NINE MILE POINT NUCLEAR STATION

SUBJECT: Nine Mile Point Nuclear Station
Unit No. 1; Docket No. 50-220

American Society of Mechanical Engineers (ASME) Code, Section XI, Inservice Inspection Program for the Third Ten-Year Inservice Inspection Interval - 10 CFR 50.55a Request Number ISI-25, Response to NRC Request for Additional Information (TAC No. ME2812)

**NINE MILE POINT UNIT 1
RESPONSE TO NRC REQUEST FOR ADDITIONAL INFORMATION
REGARDING THIRD TEN-YEAR INSERVICE INSPECTION INTERVAL
10 CFR 50.55a REQUEST NUMBER ISI-25**

Figure 3

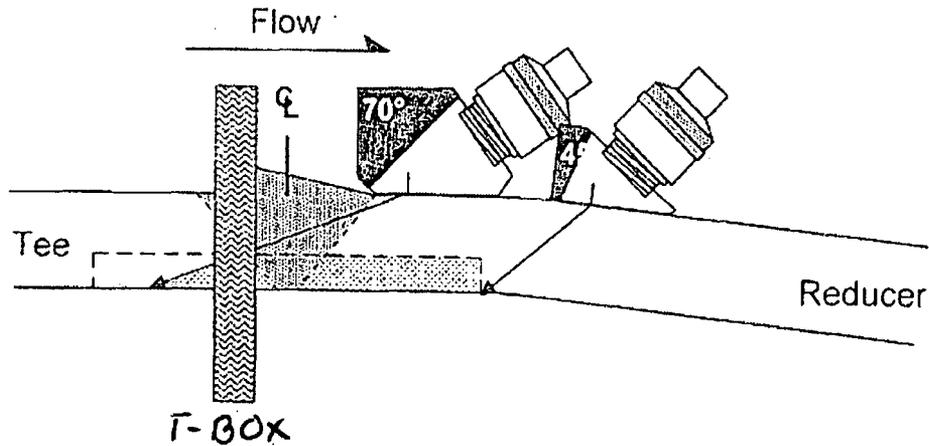
During the review of design documentation to confirm the component and weld material information, it was determined that the Note on Figure 3 for weld 33-WD-055 incorrectly characterized the weld as austenitic. Weld 33-WD-055 is actually a carbon steel weld. Figure 3 has been corrected accordingly (see Attachment 2).

Weld Identification: 33-WD-055
Weld Configuration: Reducer-to-Tee
Limitation: Single side examination due to configuration. Welded T-box
Search Units: 45 degree shear wave, 0.25' round, 5.0 mhz.
70 degree shear wave, 0.25'' round, 5.0 mhz.
Materials: Tee – ASME SA 420, GR WPL6; Weld – Carbon steel, E70S-2; Reducer – ASME SA 420, GR WPL6
Thickness: 0.432''
Coverage Achieved: 61.7%
Note: In accordance with Supplement 2 of Appendix VIII, welds limited to single-sided access that are equal to or less than 0.50-inch thick were examined using 45-degree and 70-degree shear waves. When examination from both sides is not possible on carbon steel welds, full coverage from a single side may be claimed only after completing a successful single-sided Appendix VIII demonstration using flaws on the opposite side of the weld. NMPNS has qualified a single-sided examination for carbon steel welds.

Figure 5

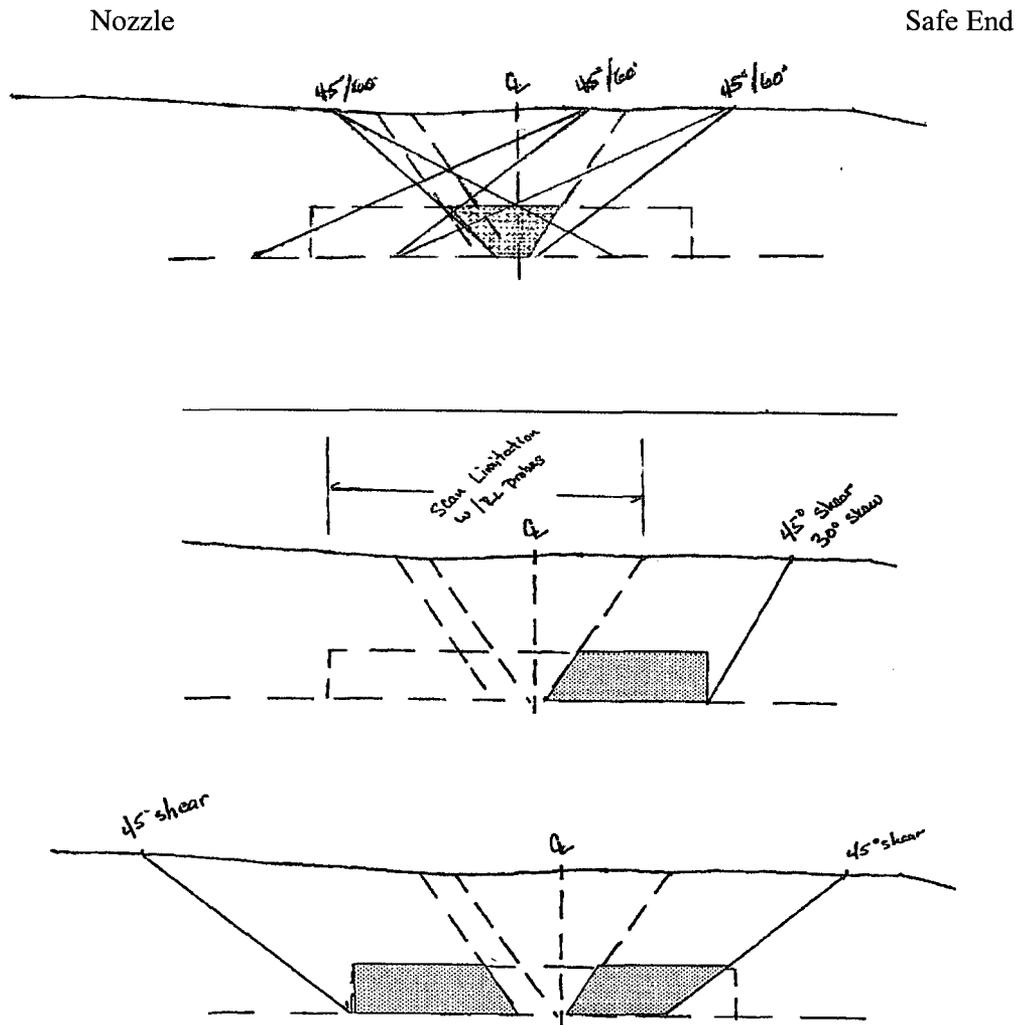
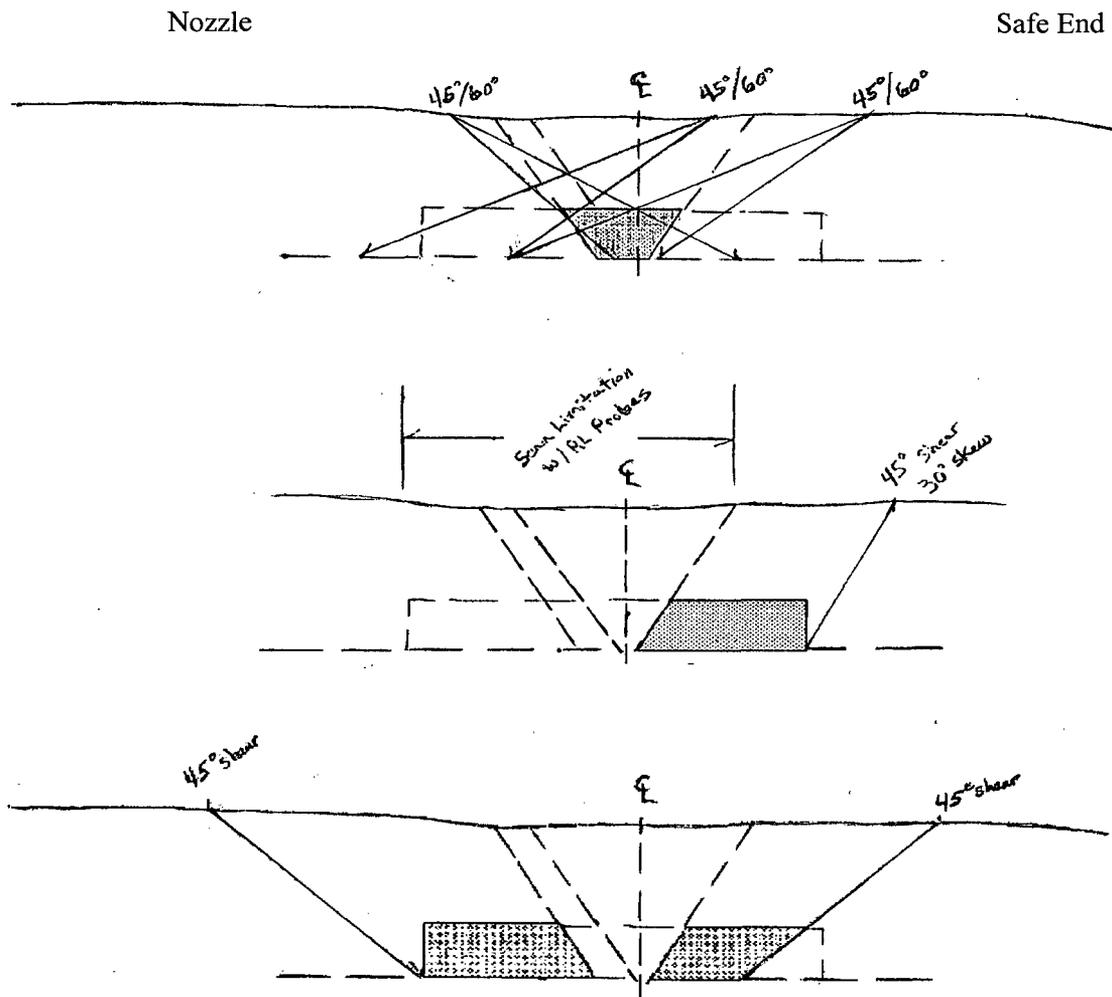
Please explain how you calculated 62.5% weld coverage for components 32-WD-002 and 32-WD-045.

Under "Risk Category 4 Welds," you state that "surface conditioning may have improved the ability to scan over the weld; however, Code coverage would not have increased because of Title 10 of the Code of Federal Regulations 50.55a(b)(xv)(A)(2) requirements...therefore, surface conditioning was not performed." Figures 5 and 6 for components 32-WD-002 and 32-WD-045, respectively, indicate that the welds are accessible for examination from both sides. In light of this, please clarify why surface conditioning to improve the surface profile due to radial shrinkage would not have increased Code coverage.

NMPNS calculated the overall weld coverage for components 32-WD-002 and 32-WD-045 by averaging the individual weld coverages obtained, as follows:

- 100% coverage of the required examination volume for the detection of circumferentially oriented flaws was obtained in two directions (axial scans were performed from both sides of the weld).
- 25% coverage of the required examination volume for the detection of axially oriented flaws was achieved on the safe end side of the weld in the clockwise and counter-clockwise directions.

Thus: $(100\% + 100\% + 25\% + 0\%) / 4 = 225\% / 4 = 62.5\%$ weld coverage

For weld numbers 32-WD-002 and 32-WD-045, the required volume was examined with 100% coverage achieved for the detection of circumferentially oriented flaws, with scans performed from both sides of the weld. However, only 25% coverage was achieved for the detection of axially oriented flaws, with scans performed on the safe end side of the weld only.

The reduction in coverage for axially oriented flaws was caused by a surface condition (radial shrinkage) that reduced the effectiveness of circumferential scans as the search units traversed above the austenitic weld and nozzle materials. Some coverage of the safe end side of the weld was obtained, and the heat affected zone was interrogated.

Surface grinding to improve coverage was considered, but was not performed because the estimated amount of material to be removed on the nozzle side could have encroached on the minimum wall thickness. A full structural weld overlay would also have improved the surface condition; however, this repair activity had not been pre-planned. There were concerns with attempting to develop a high-quality weld overlay design package, procuring and mobilizing resources to perform the weld overlay, and minimizing radiation dose impacts during the existing outage. Thus, a weld overlay repair was not pursued.

The examinations for weld numbers 32-WD-002 and 32-WD-045 were performed to the extent practical with no reportable indications detected. NMPNS has concluded that the extent of examination coverage achieved along with the system pressure tests performed provide reasonable assurance of the continued structural integrity of these welds.
